Kennecott Eagle Minerals

Re: File Number 08-52-0104-P, Humboldt Mill Joint Permit Application for an Inland Lakes and Streams Permit, Kennecott Eagle Minerals Company

In a letter dated January 7, 2009 a request for clarification/information was received from the Land and Water Management Division (LWMD) titled "Application Correction Request." In fulfillment of your request, please find attached, answers to your questions, additional engineering detail and supporting documentation.

FIGURE 2-1

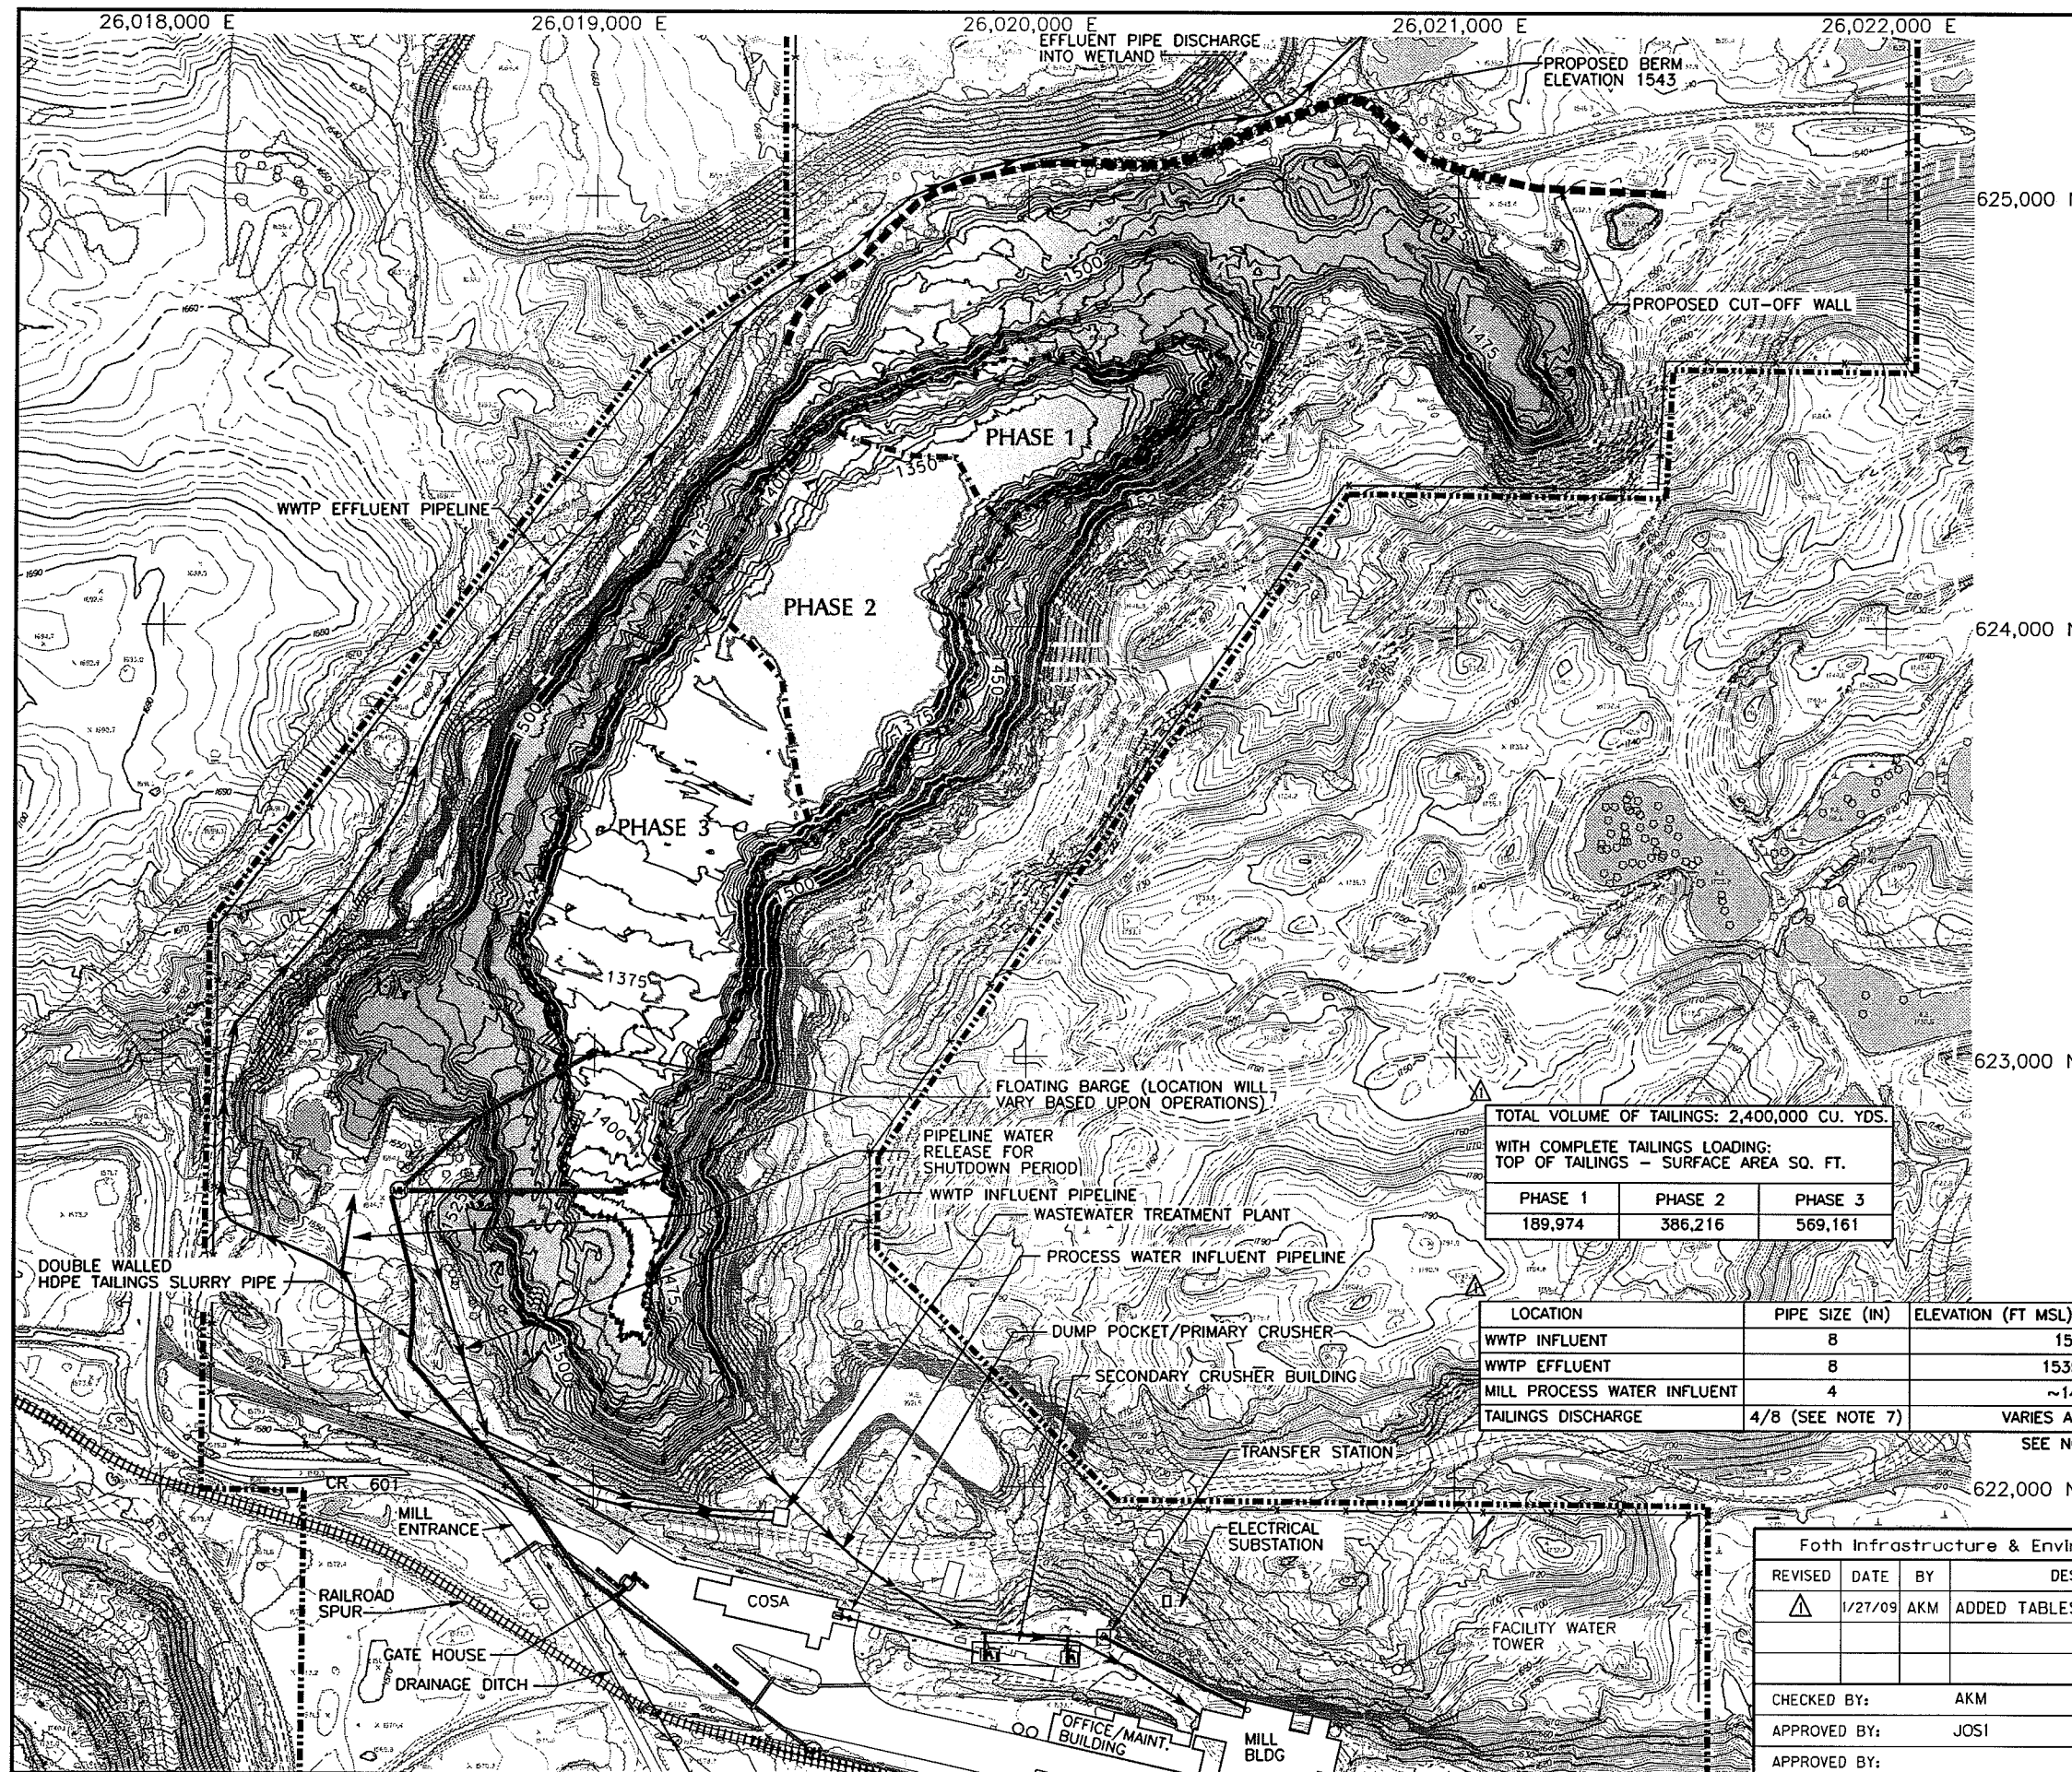
2. Provide the pipe diameters and invert elevations in Section 10J

Figure 2-1 has been updated to include the surface area of the top of the tailings for each phase. Figures 2-3 and 2-4 now include a table with the following information regarding the proposed tailings fill for Sections A-A', B-B', C-C' and D-D':

There was not enough space within section 10J to include the pipe diameters and elevations for all four intake and outlet pipes. This information has been included on Figures 1-3, 2-1 and 2-5 (Attachment C).

FIGURE 2-5

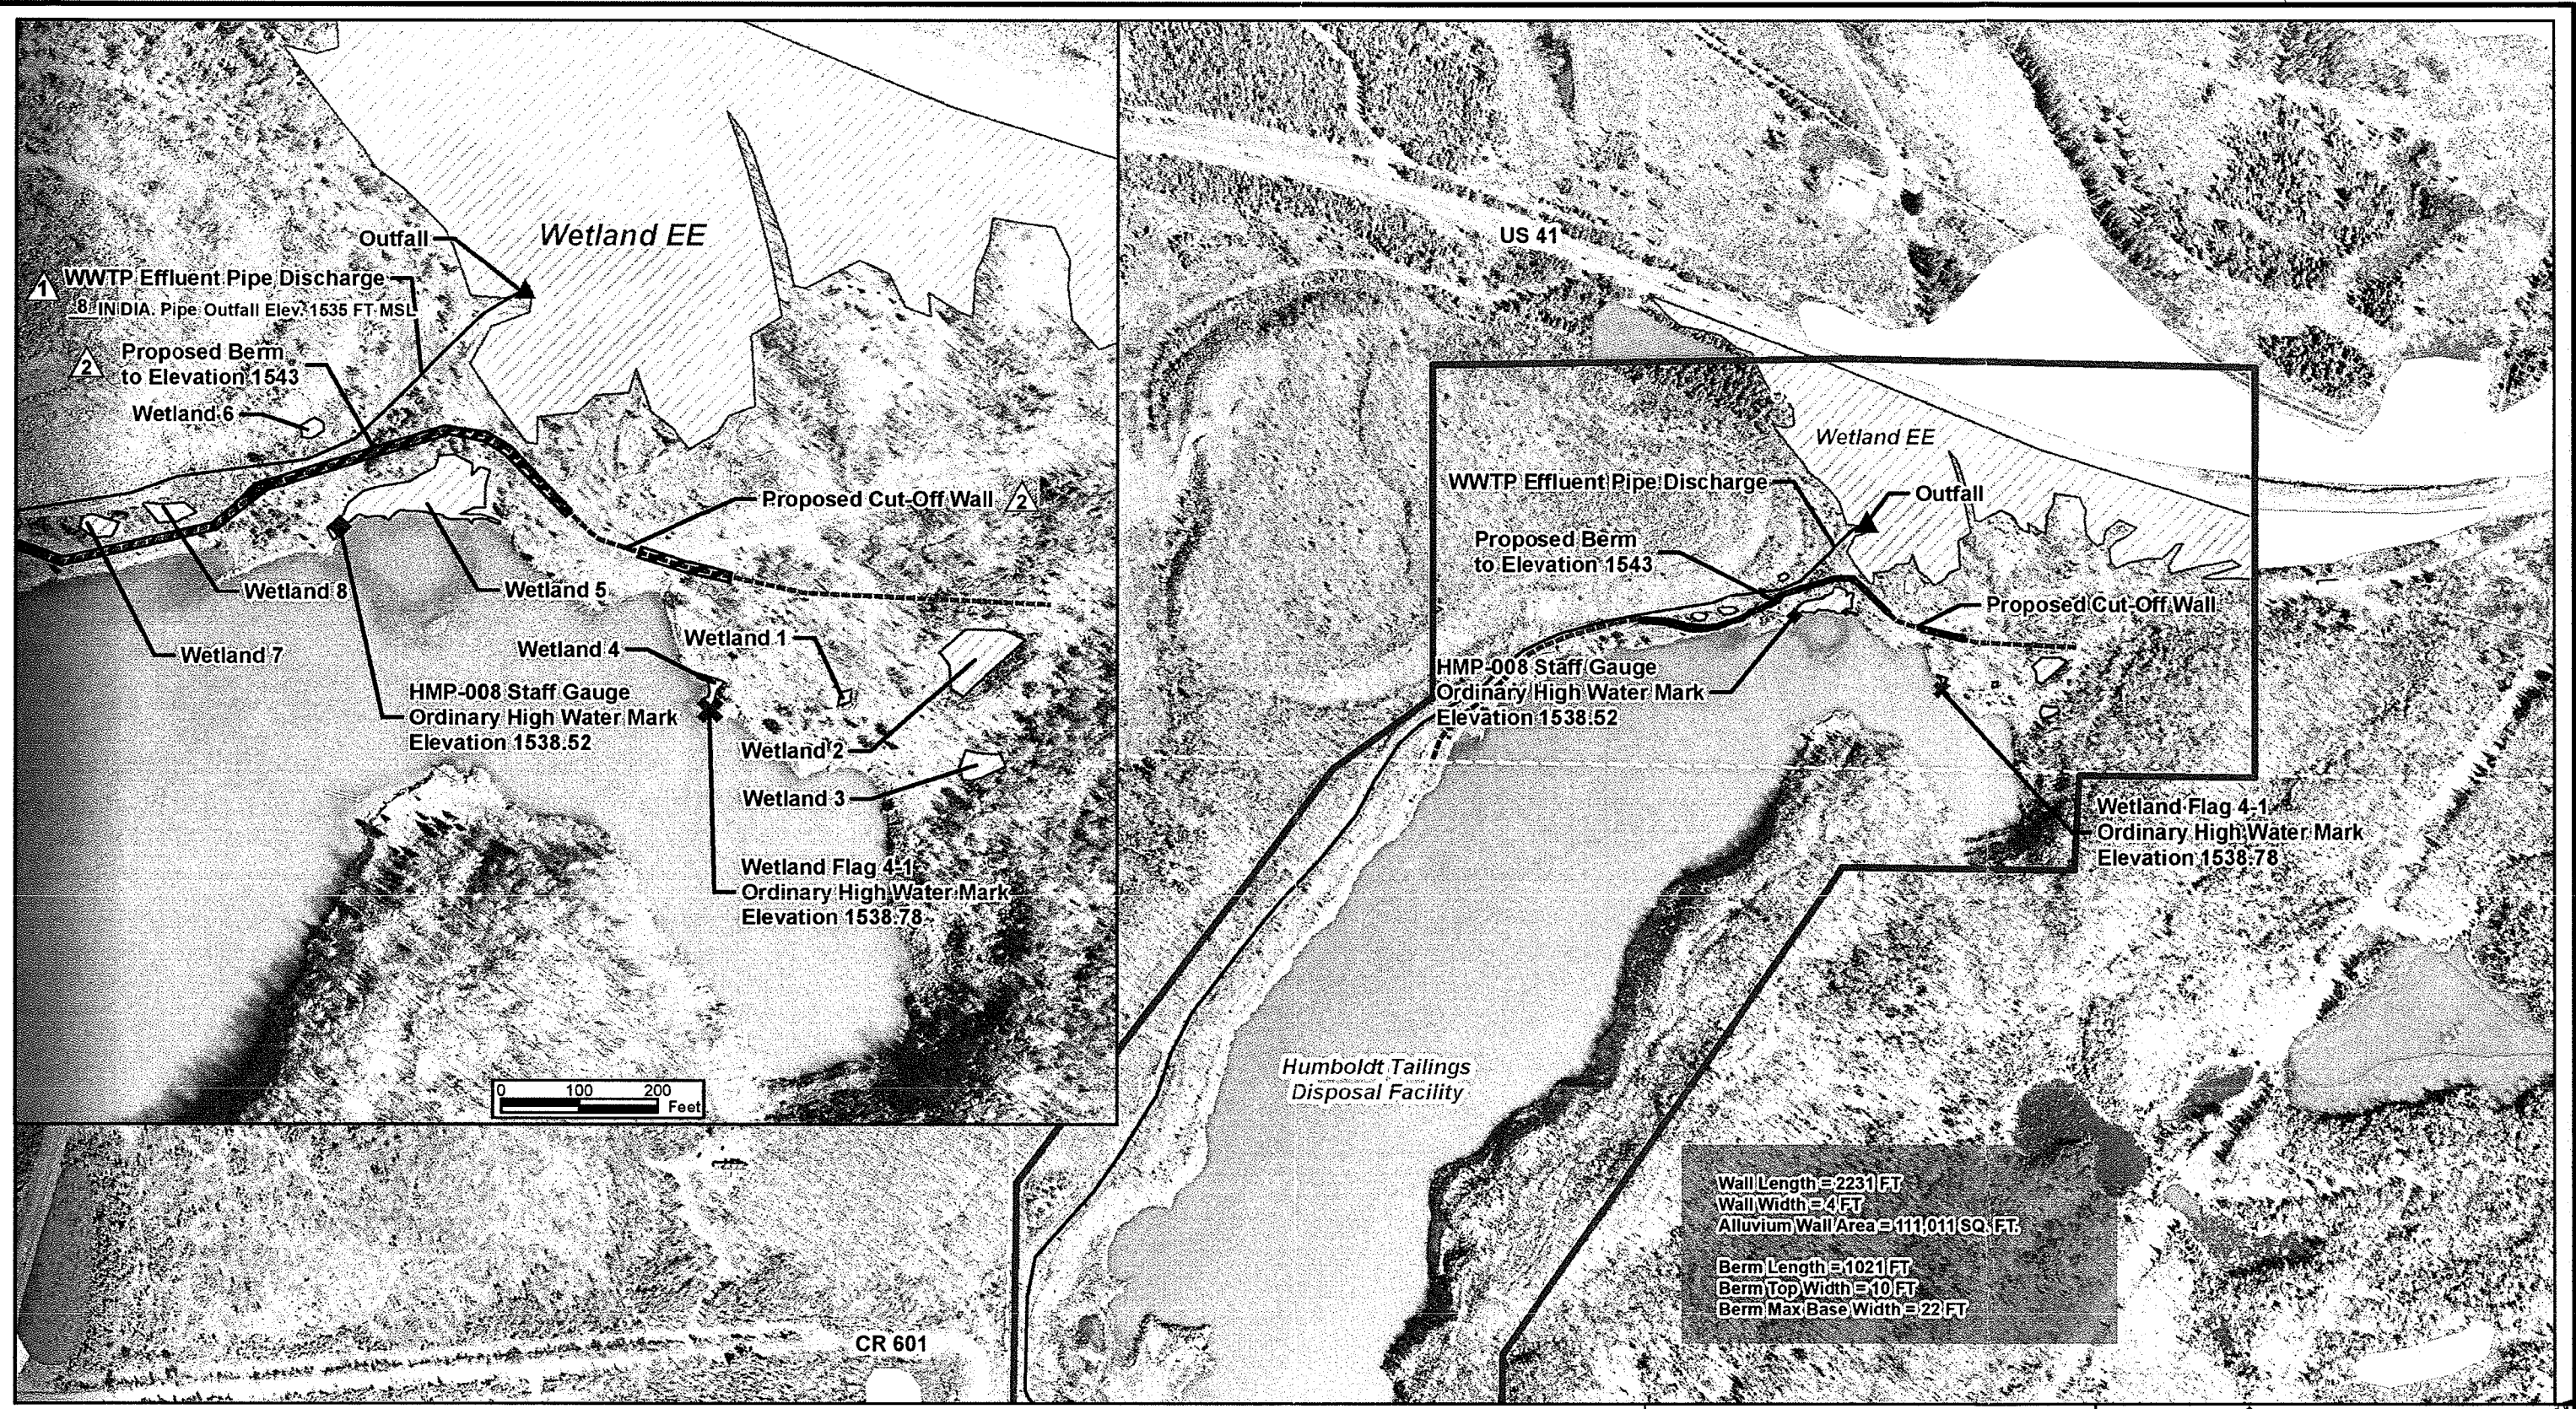
5. On Figure 2-5 show the dimensions of the wall and berm.

KEMC Response: *Dimensions for the cutoff wall and berm have been added to Figure 2-5. An updated version of Figure 2-5 is included in Attachment C.*

KENNECOTT EAGLE MINERALS
FIGURE 2-5a HUMBOLDT
TAILINGS DISPOSAL FACILITY
CIVIL
CUT OFF WALL
JOB NO. M3-PN09005
DWG NO. 000-EN-001
REV NO. P1
08 FEB 09

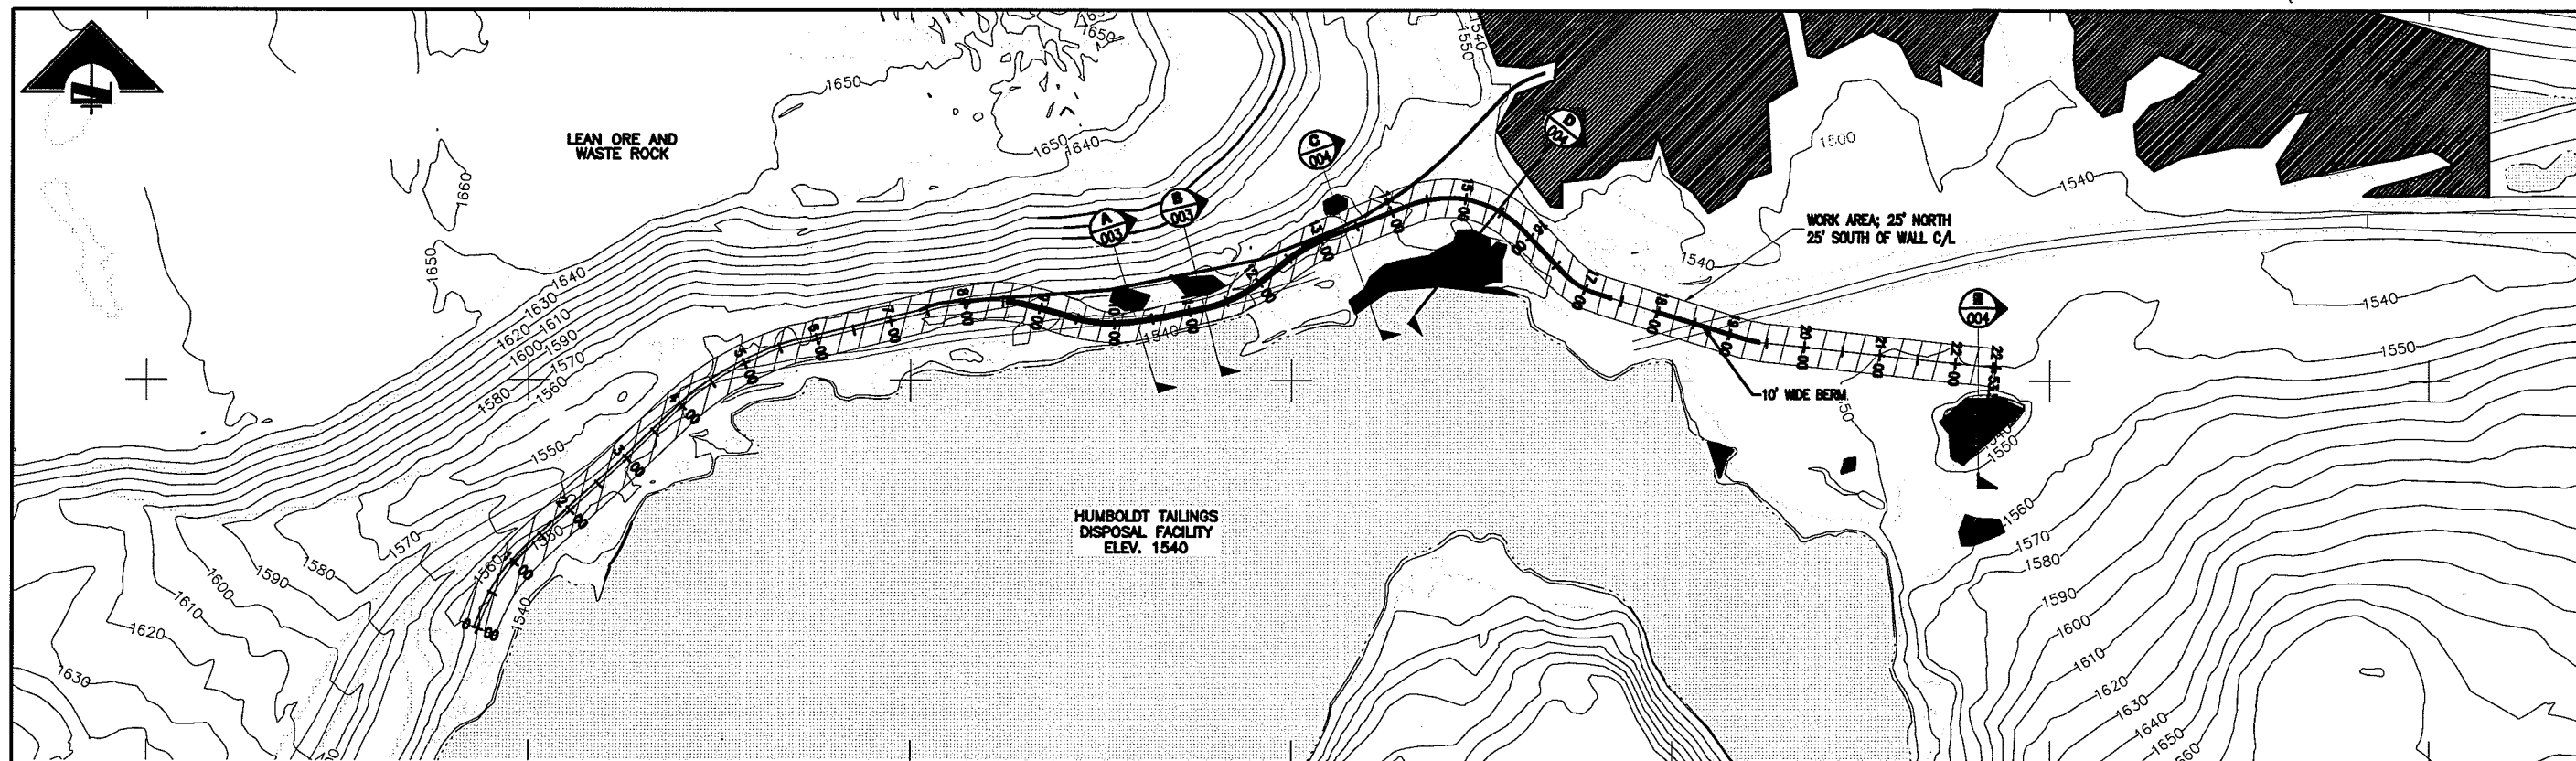
6. Provide black and white cross sections of the cutoff wall / slurry wall and berm showing boundaries of adjacent wetland, width of work area, and structure dimensions. Include height, base and top widths of the berm. Indicate length of the proposed berm. Enclosed is a site plan for reference.

KEMC Response: *Three new drawings have been attached which provide all the information requested in Question 6:*

Figure 2-5a shows the cutoff wall and berm details in detail, profile and plan view, Figure 2-5b provides information for Sections A-A' and B-B' and Figure 2-5c contains Sections C-C', D-D' and E-E'. Copies of all three new figures are contained in Attachment D.
